Planning and Access Committee

Agenda item: 5

APPLICATION NUMBER:	19/02544/PP (Argyll & Bute Council reference)
APPLICANT:	Muirden Energy LLP
LOCATION:	Creag Dhubh Windfarm Creag Dubh North East Of Strachur Village Argyll And Bute situated over 1km to the northeast of the village of Strachur, with the proposed wind turbines located approximately 3km from the village.
PROPOSAL:	Construction of wind farm comprising of 9 wind turbines (maximum blade tip height 145m), formation of 5.6km new access track, erection of substation building, welfare building, temporary construction compound and 2 borrow pits
COMMUNITY COUNCIL AREA	Strachur
CASE OFFICER:	Name: Amanda Muller Tel: 01389 727721 E-mail: amanda.muller@lochlomond-trossachs.org

Figure 3 -LVIA photomontage of summit views to the proposal

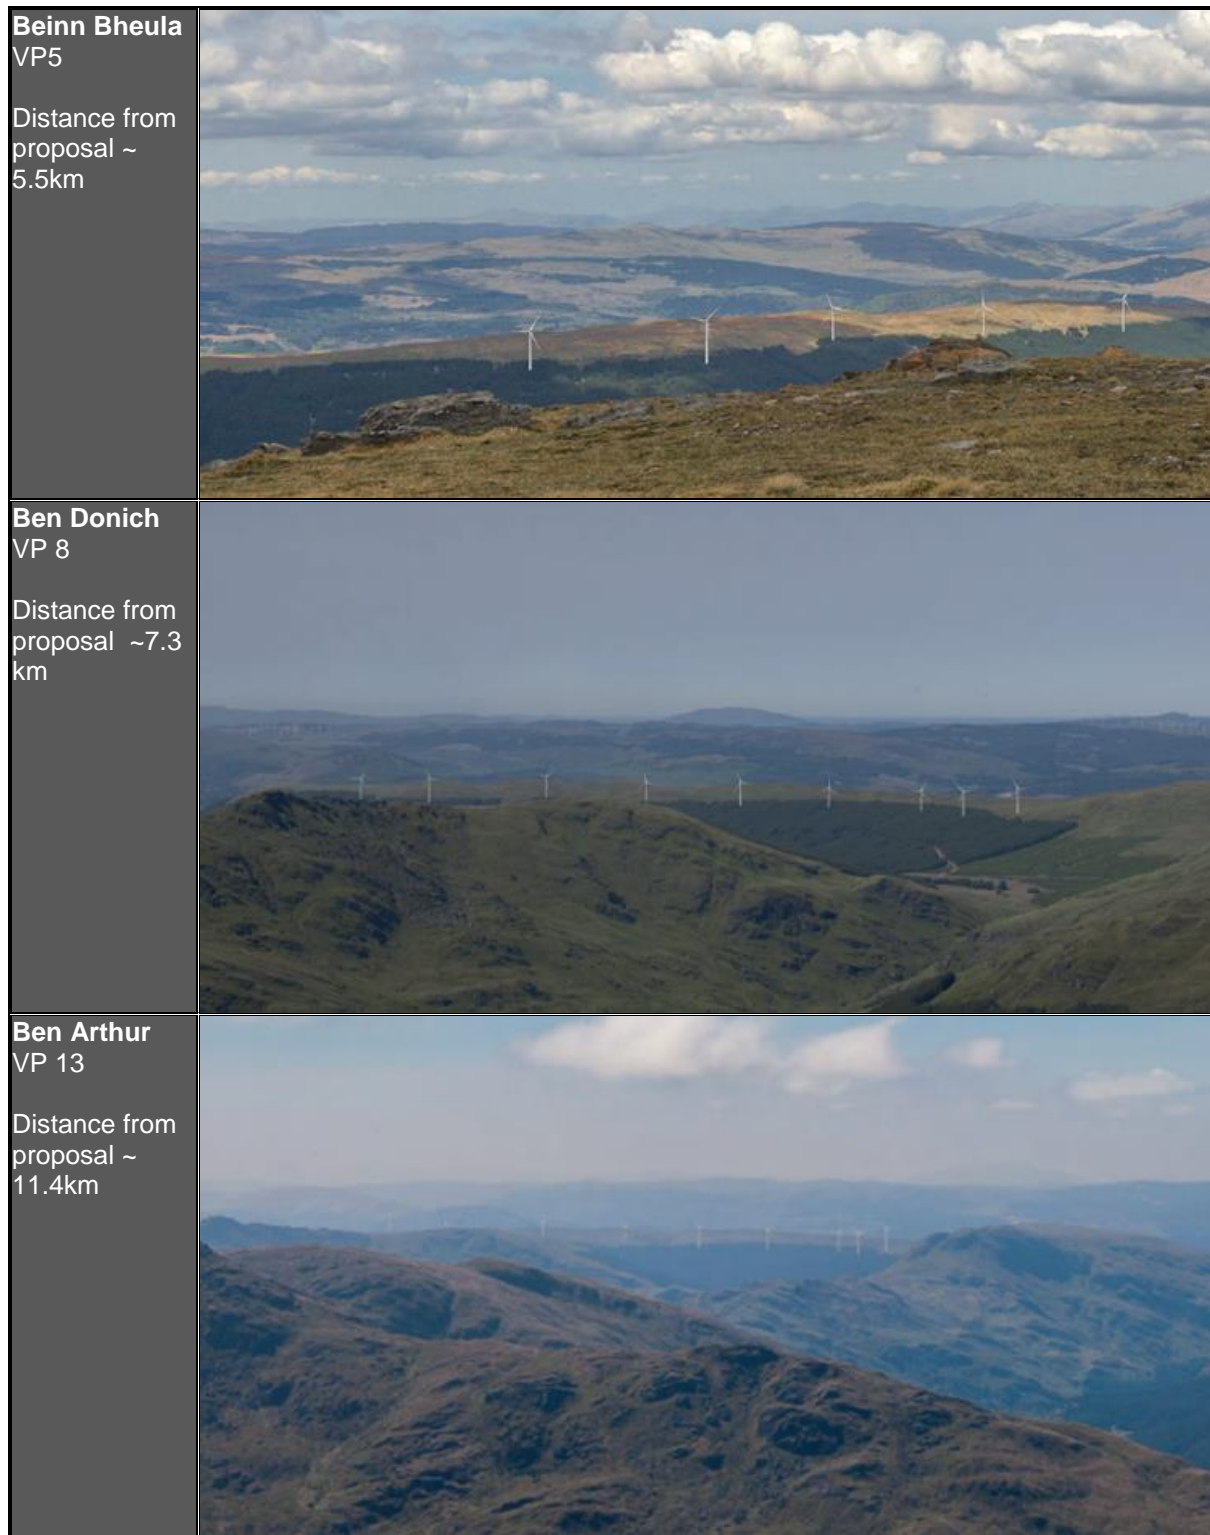
7.23. The National Park Authority does not agree with the conclusion of the applicant's LVIA assessment which has assessed the effects to the Special Landscape Qualities to be not significant. The National Park Authority has assessed the proposal and is of the opinion that this will have significant detrimental effects to the experience of views of walking routes popular with visitors and residents in the Park Authority.

Figure 4- Cumulative Wind Farms in LVIA Study as listed in Table 2

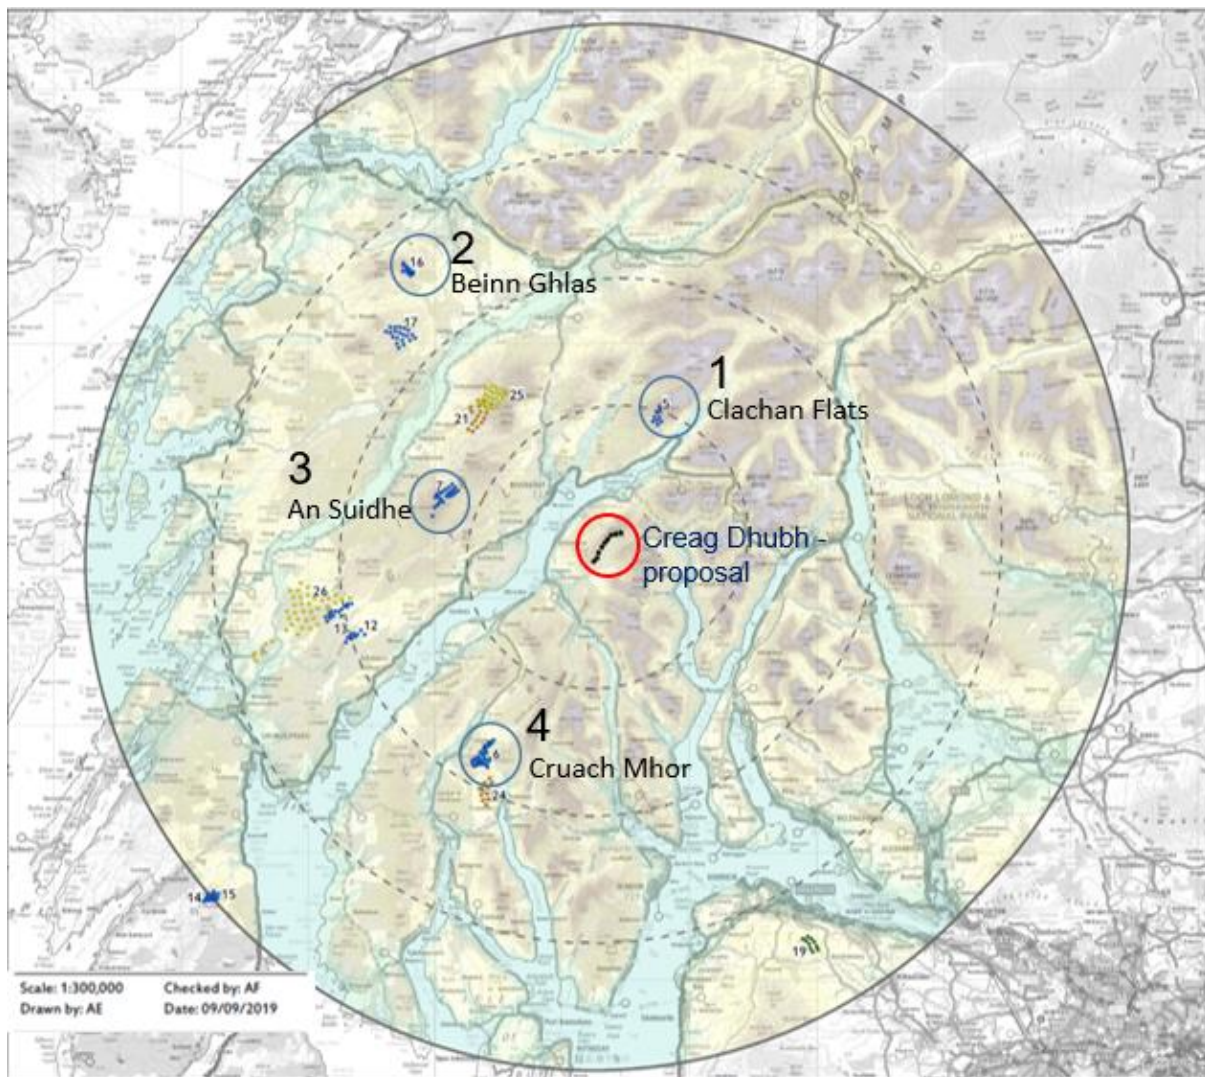
7.24. It is also noted that all operational windfarms around Loch Fyne are below 100m blade tip height and significantly further from the NPA boundary than the current proposal. Existing operational windfarms are a distance of 8 to 18km from the proposed windfarm and not readily evident from the National Park summits as opposed to Creag Dhubh which is just over 1km from the National Park boundary. Table 2 and Figure 3 further demonstrate the distance and height difference of existing windfarms in relation to the Creag Dhubh proposal.

Appendix 3: Viewpoint 5 Beinn Bheula

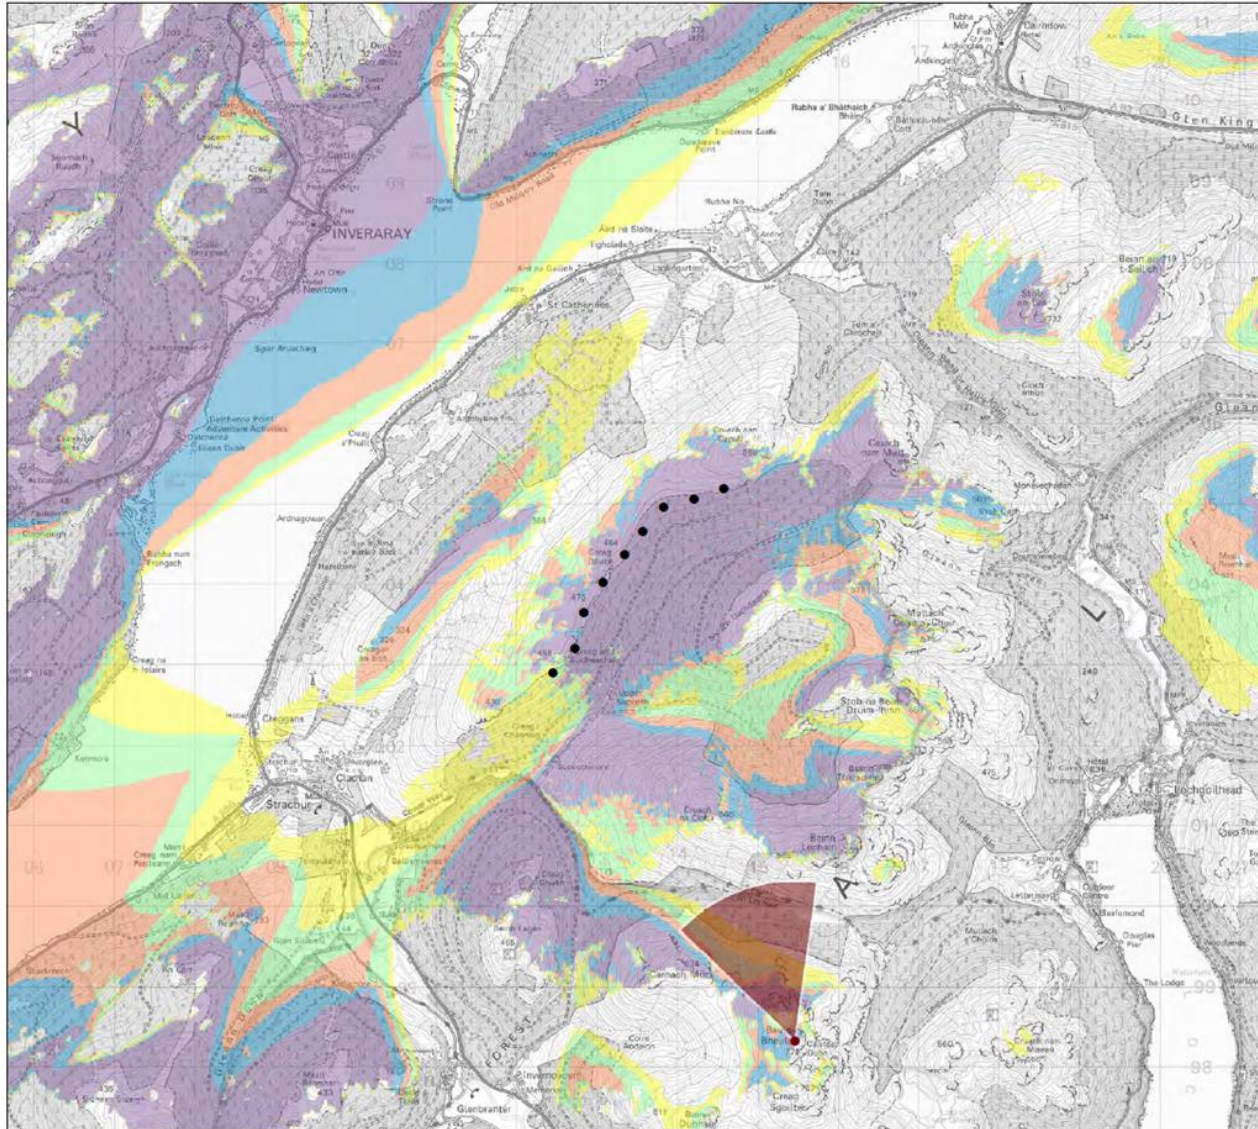
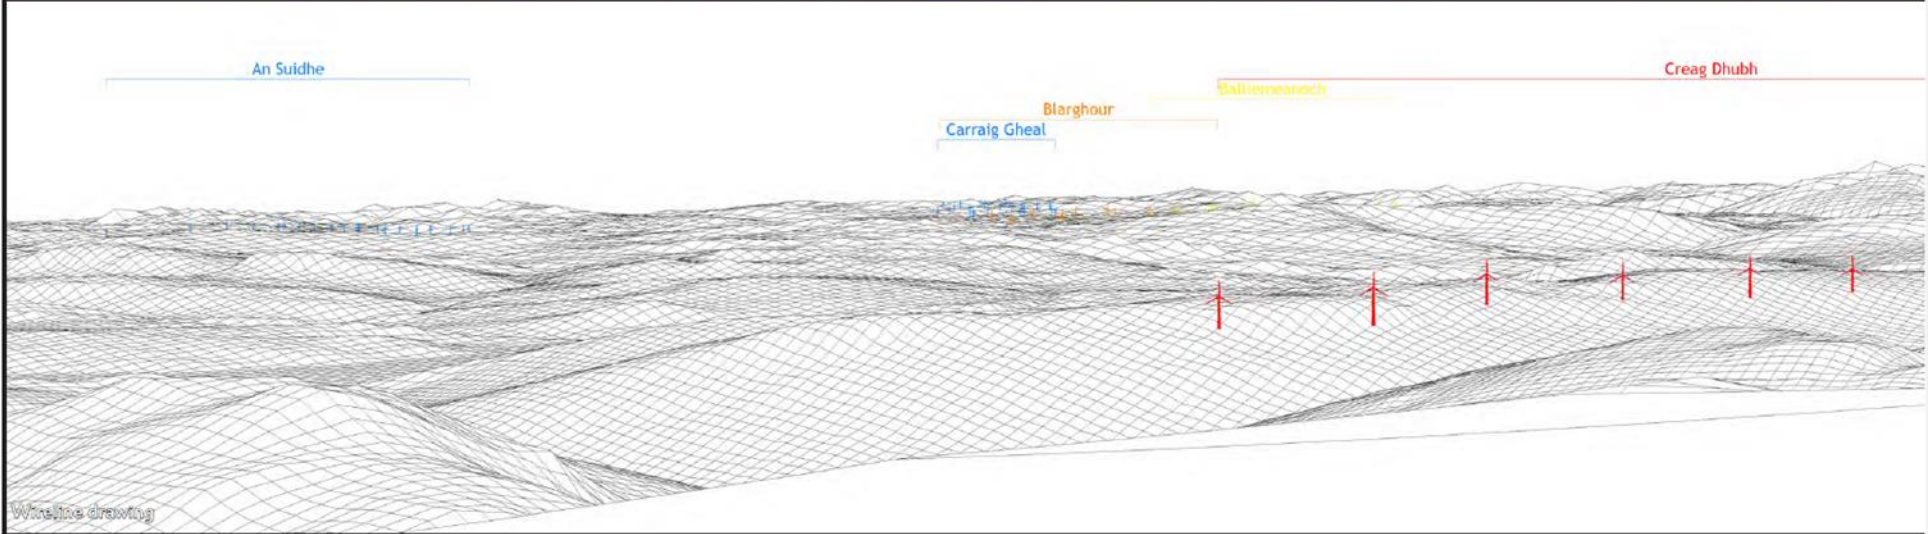
- 7.14. There would also be significant visual effects from the periphery of the Arrochar Alps area, where many of the closest summits and ridges would have views of the turbines as represented by for example Beinn Bheula VP5 and Ben Donich VP8 (attached as Appendix 3 and 4).

- 7.20. Walkers to Beinn Bheula at 5.5km from the proposal would also have sequential views of the turbines occupying a wide field of view with additional significant visual effect at the summit with all nine turbines visible (Appendix 3). The turbines would be dominantly in view for walkers to Ben Donich from the lower western southern slopes to the summit with turbines occupying a relatively wide extent of the surrounding landscape.

Appendix 5: Viewpoint 13 Ben Arthur (the Cobbler)

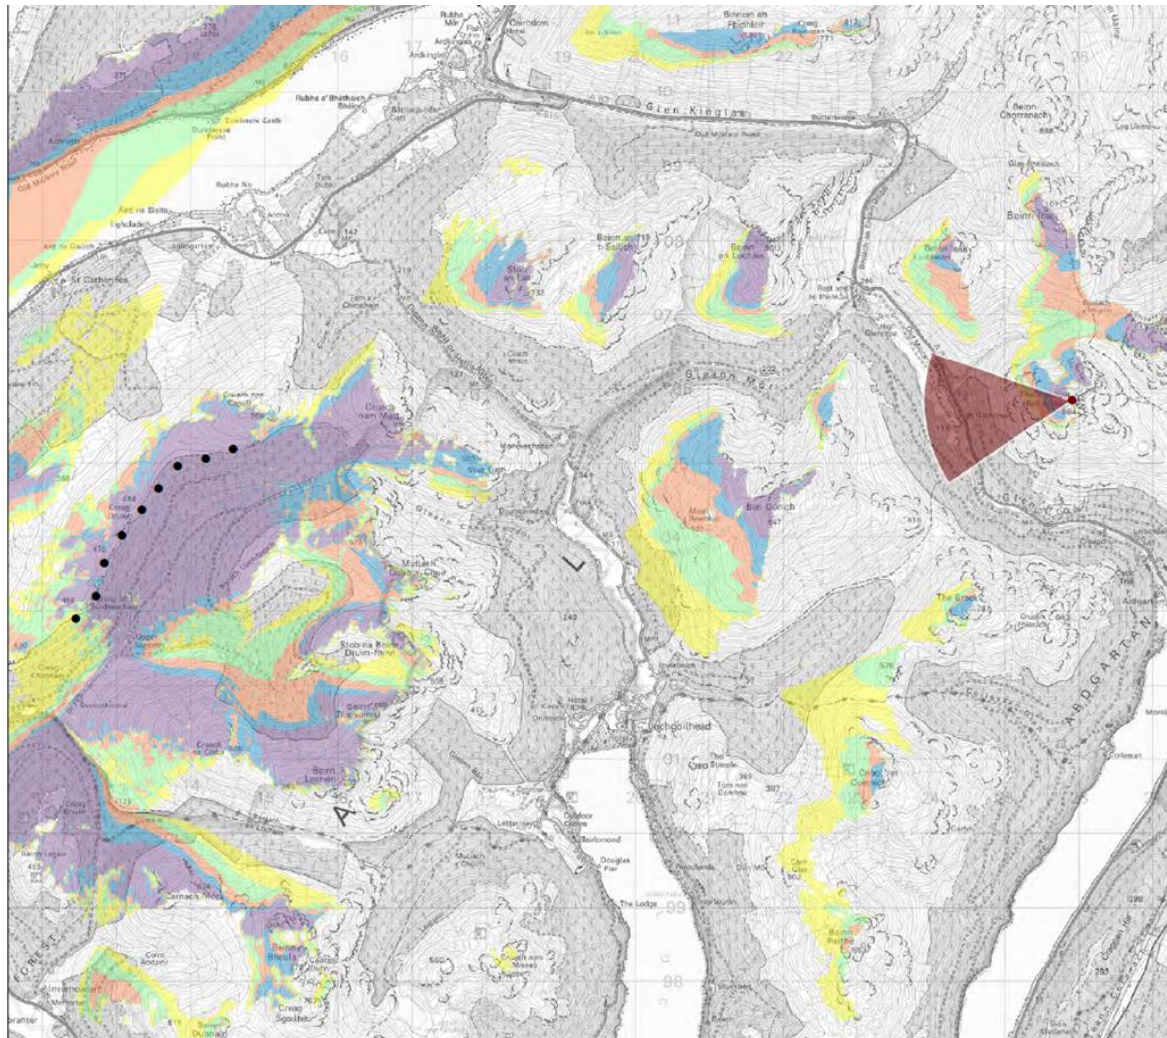
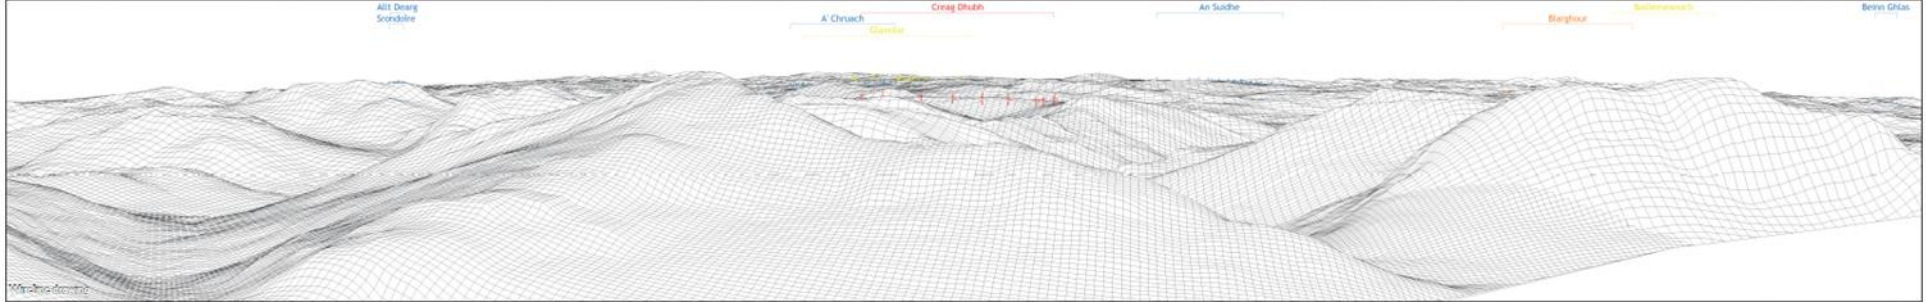
- Ben Ime (Munro) and
 - Ben Narnain (Munro)
- 7.13. The photomontage provided for Ben Arthur (viewpoint 13, attached as Appendix 5) demonstrates the full visibility of all 9 turbines at a distance of 11km.
